Access Compliance Report Public Rights-of-Way (Curb Ramps)

Main Street: RANCHWOOD_RD Cross Street: REDBERRY_RD Location: NE

ADA ID: RPAT211013142806 Ramp Type: Type 1 - Perpendicular Diagonal Initial Pass/Fail: Pass Overall Compliance: No Severity Score: 6

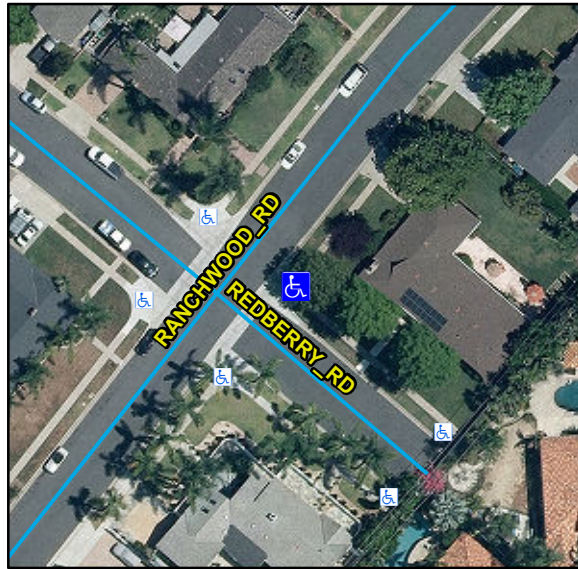
R304.2.2, R304.2.1, STD 1115

Remove & Replace Curb Ramp With Two New Directional Ramps or Equivalent.
